Lighthouse Green Fuels

Development Consent Order

PEIR Addendum (April 2026)

Planning Inspectorate Reference: EN0110025

Drawing Title
**PEIR Addendum Figure A2.1
 Site Location**

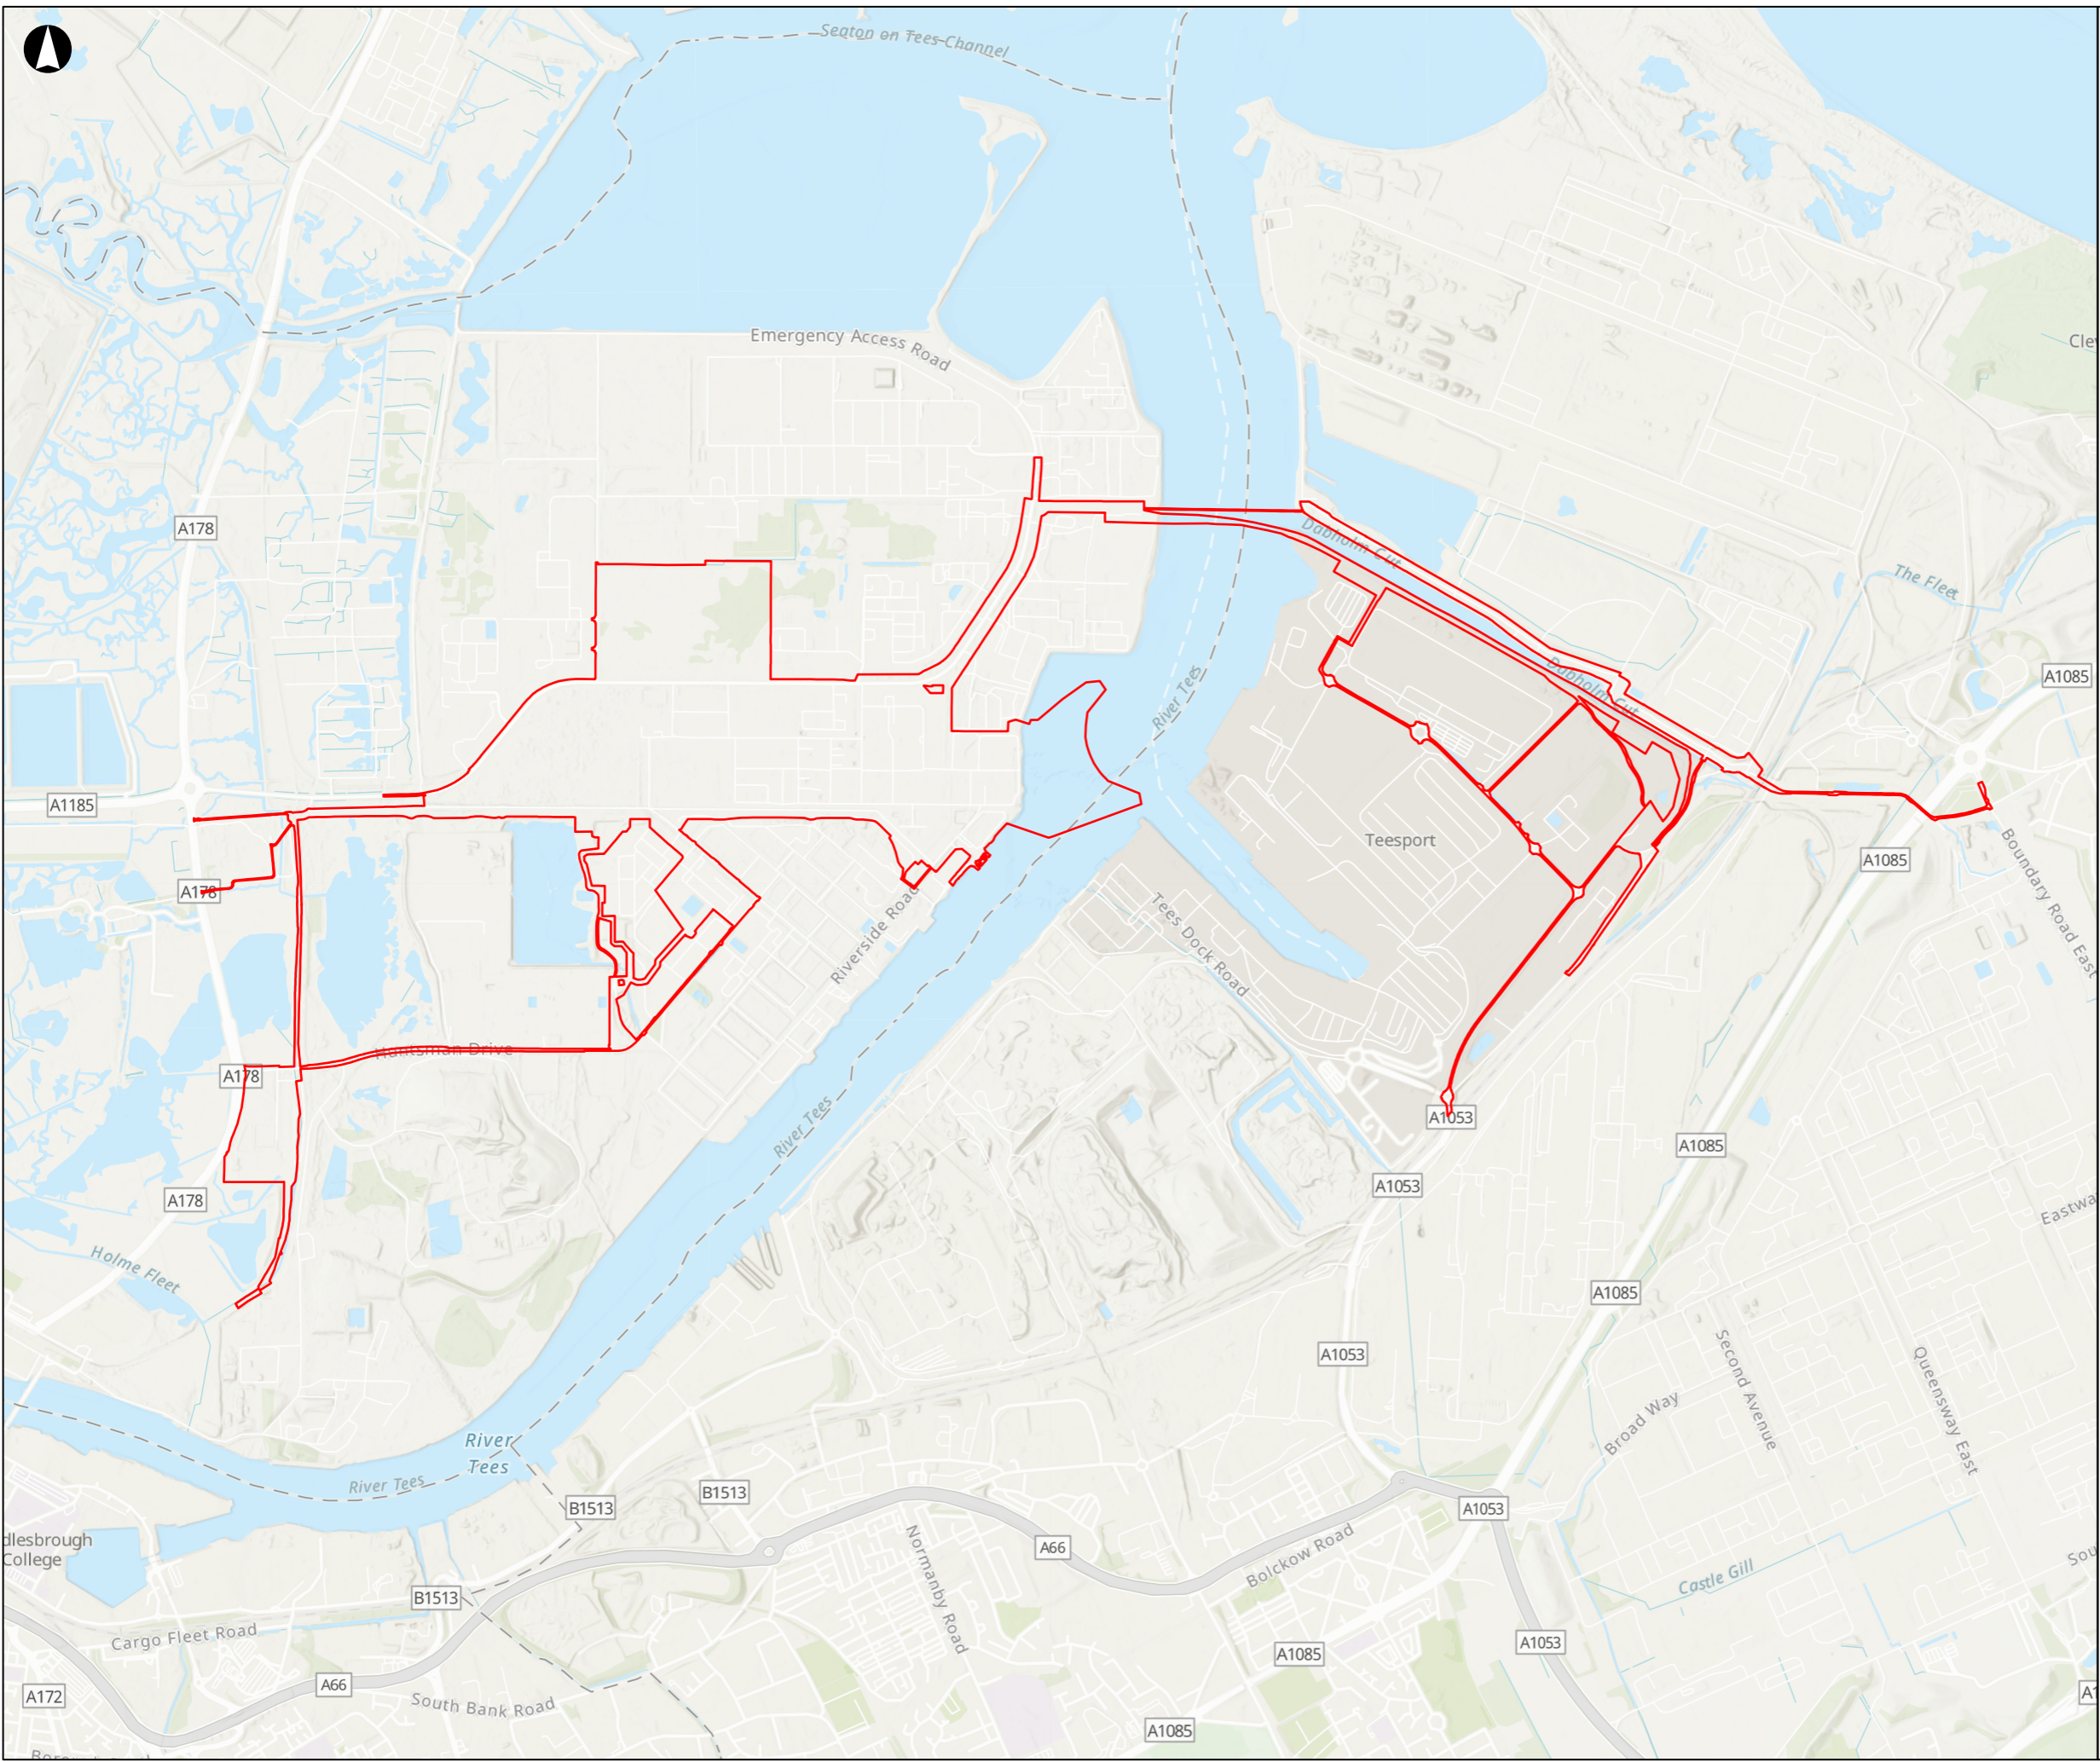
2.2.3 An updated Site Location plan is presented as Figure A2.1 of this PEIR Addendum and the updated draft Order Limits presented in Figure A2.2. A plan showing the changes between the updated draft Order Limits and the same boundary presented in the PEIR is presented as Figure A2.3.

Drawing Title
**PEIR Addendum Figure A2.2
 Updated Draft Order Limits**

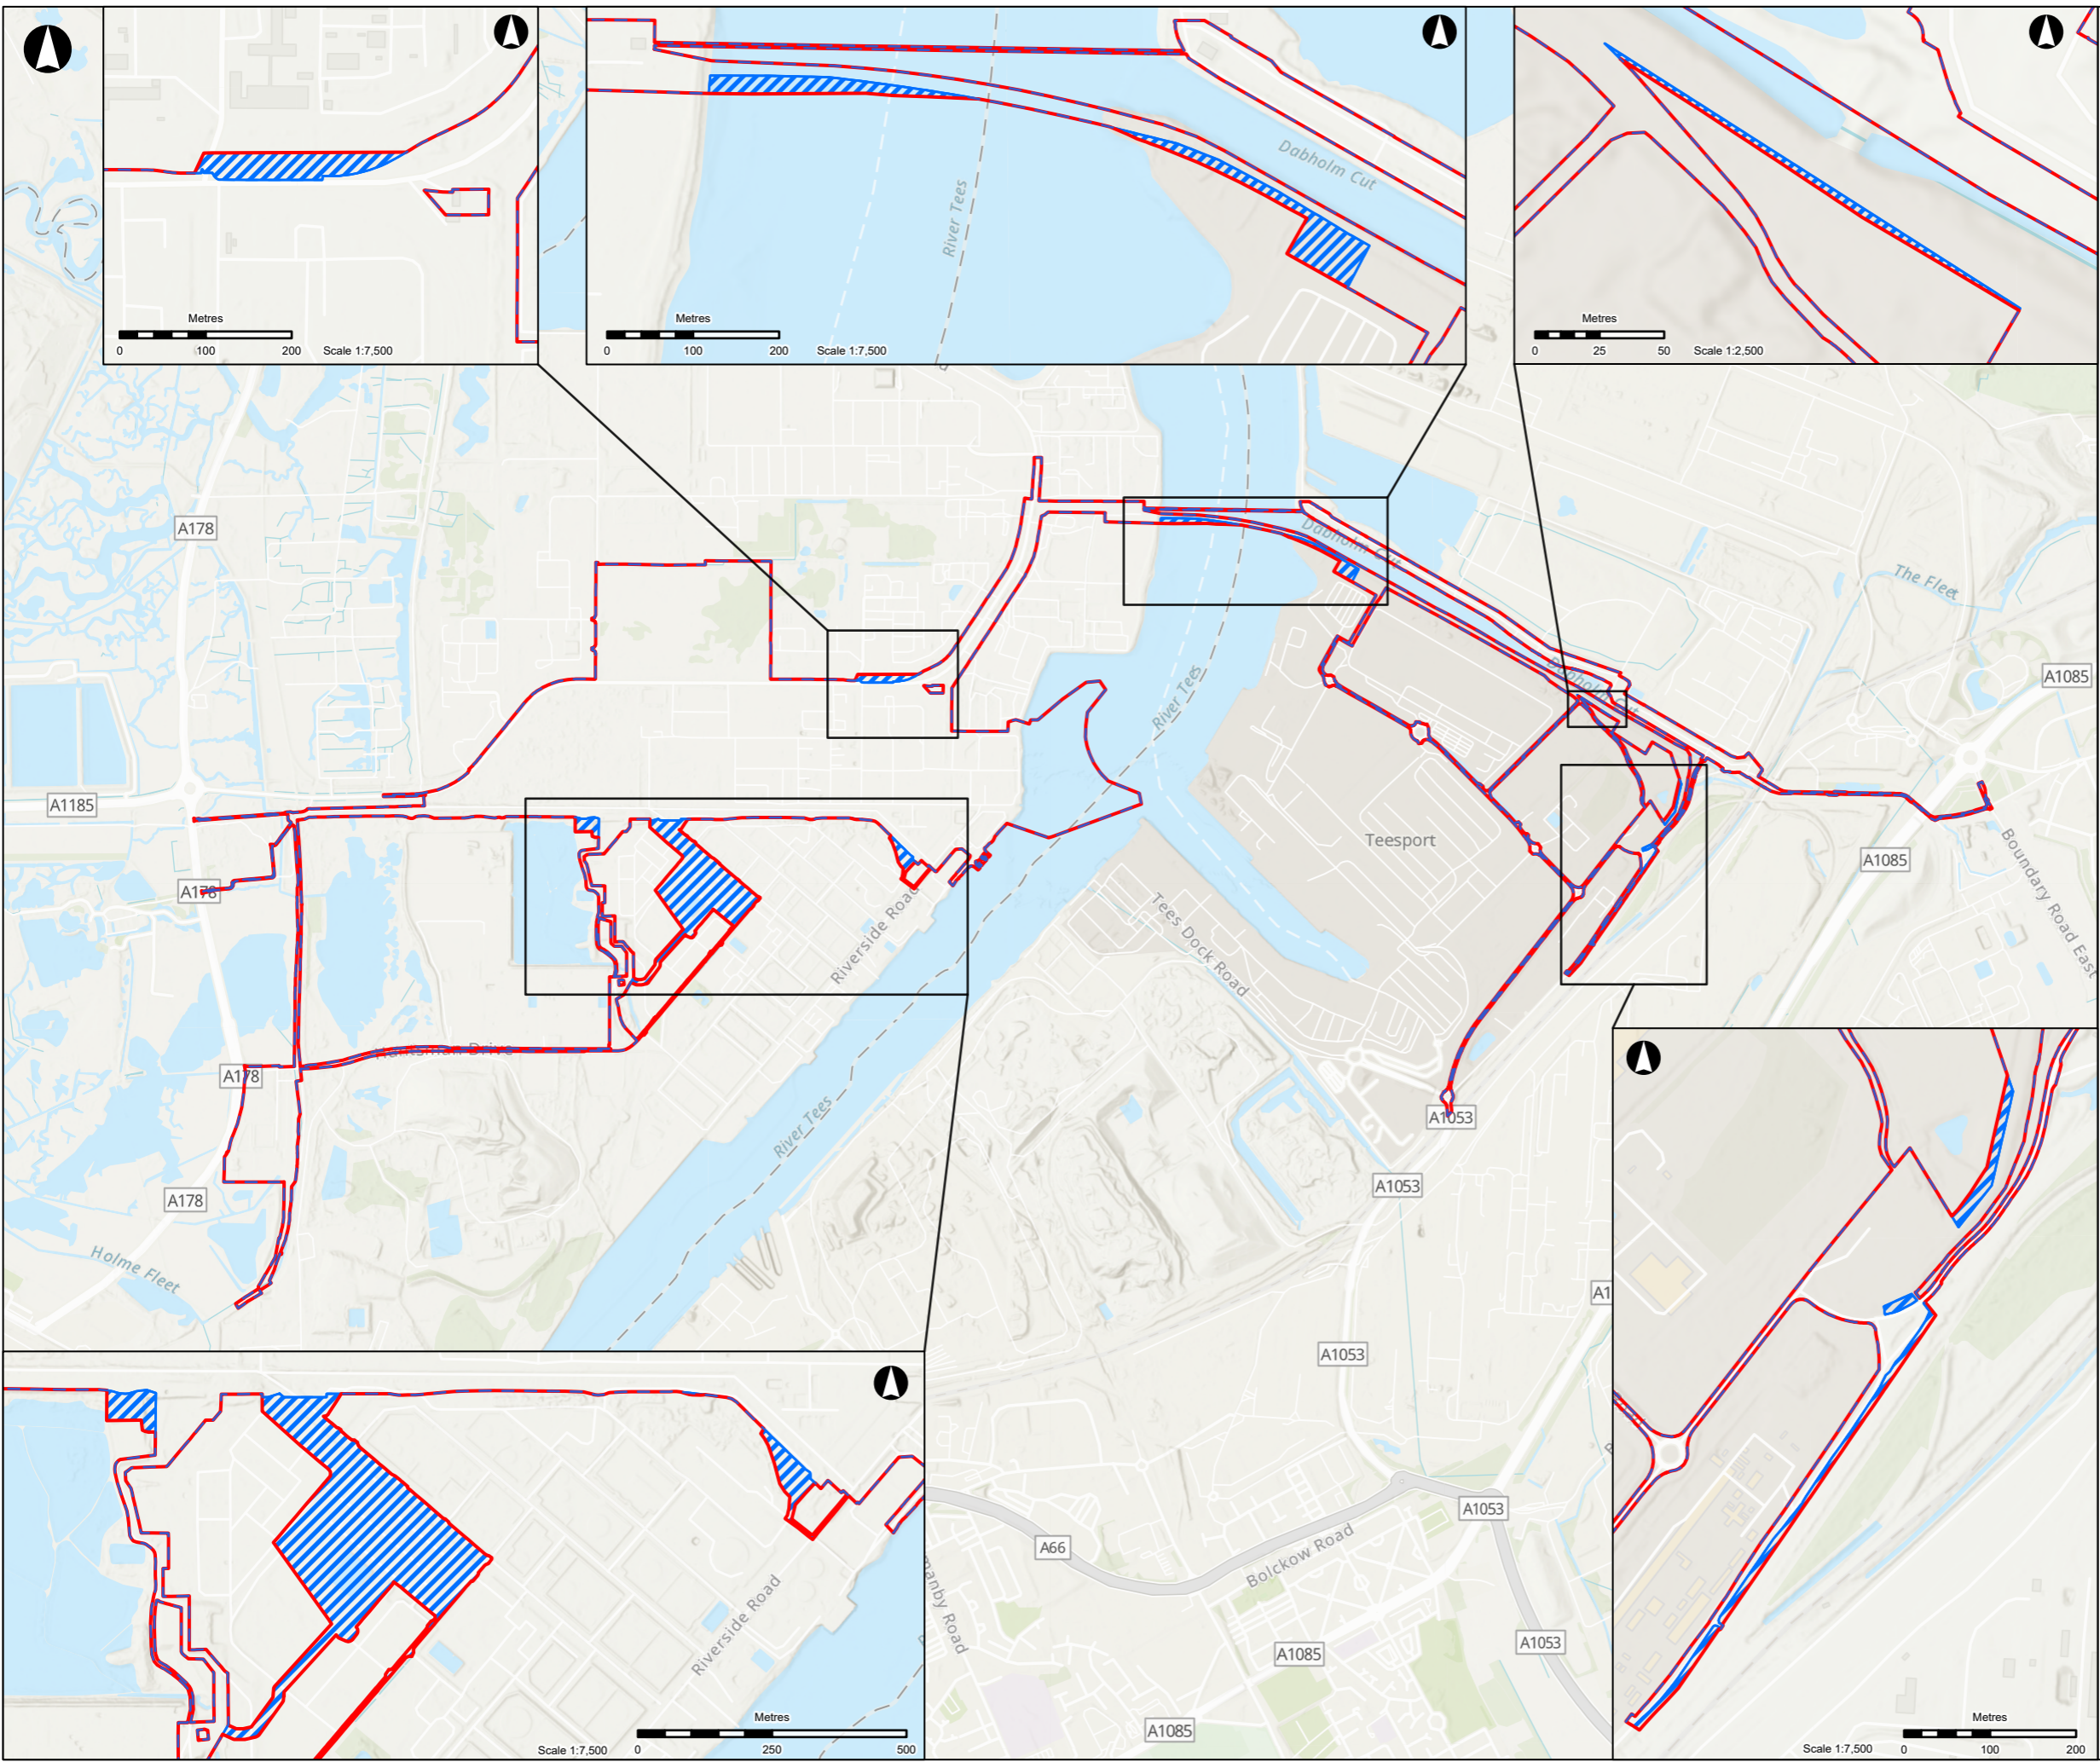
3.4.1 The Proposed Development Changes amend the Order limits such that the area of the Site has increased by 13 hectares (ha) from 218 ha to 231 ha.

Drawing Title
**PEIR Addendum Figure A2.3
 Differences between the Original and
 Updated Draft Order Limits**

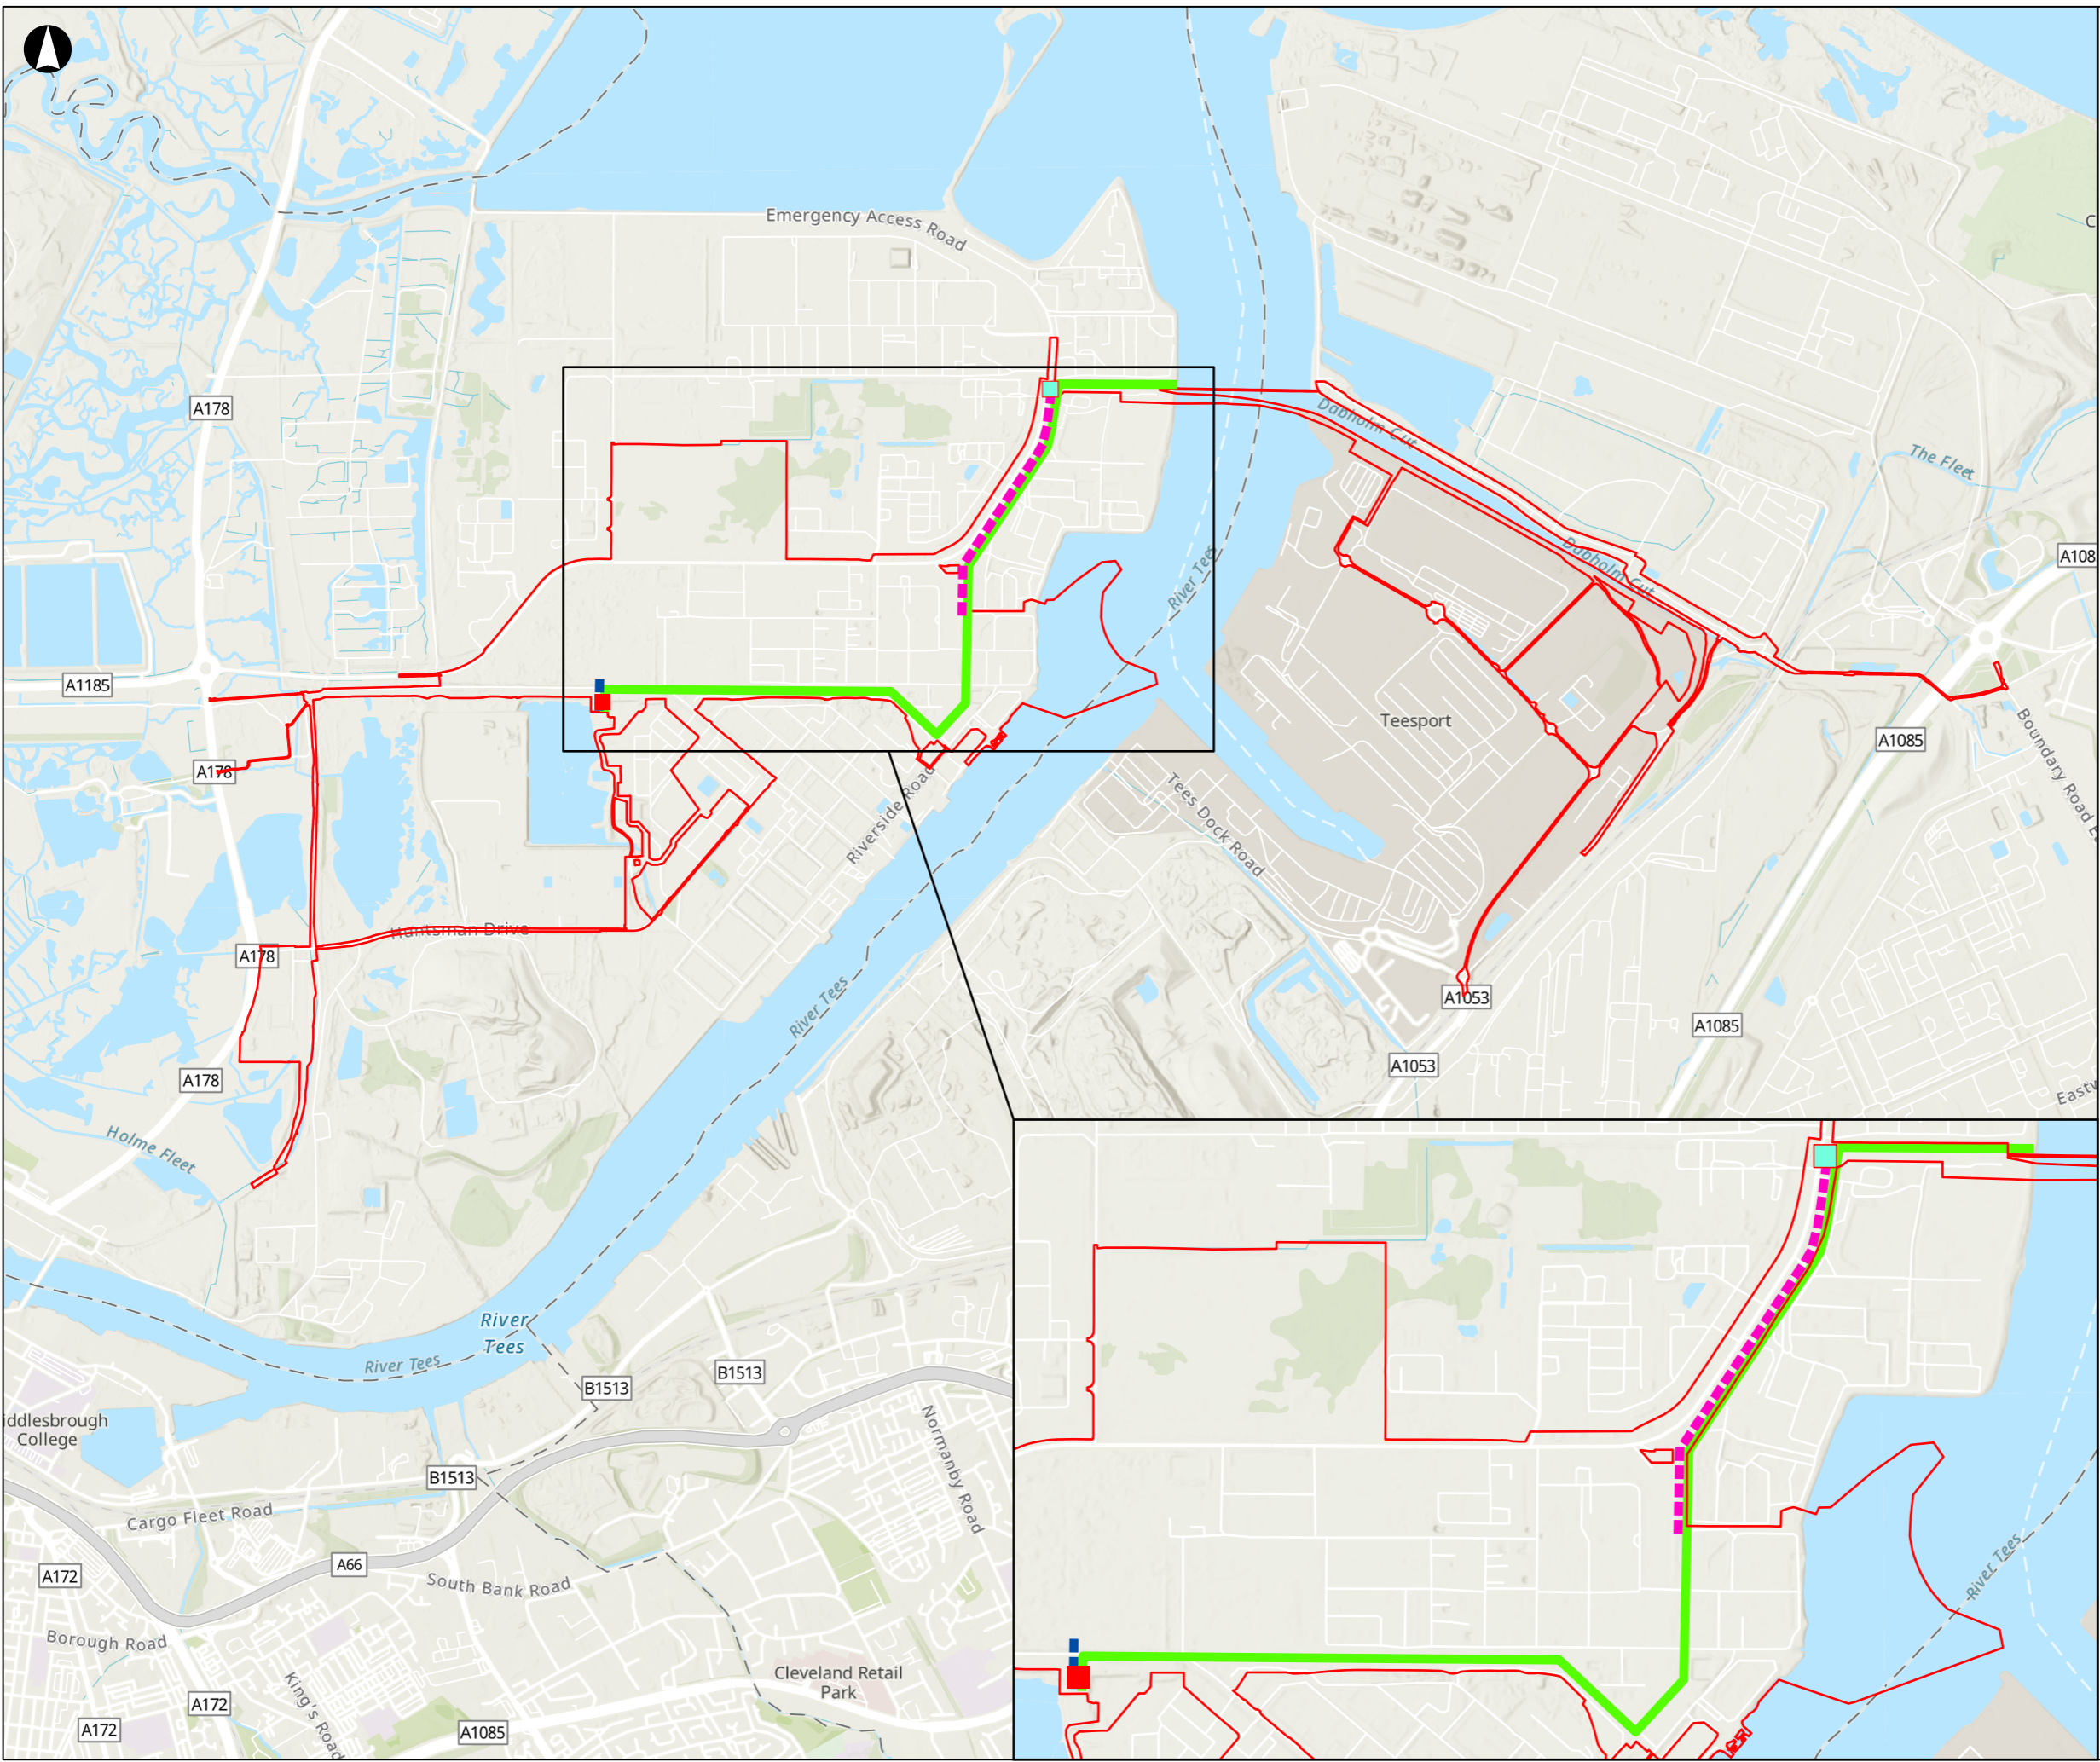
- 4.1.5 Change 4 will involve minor changes to the Proposed Development boundary which are necessary to take into account more accurate knowledge of the location of existing pipelines and services and access routes. No additional effects are anticipated from this change.
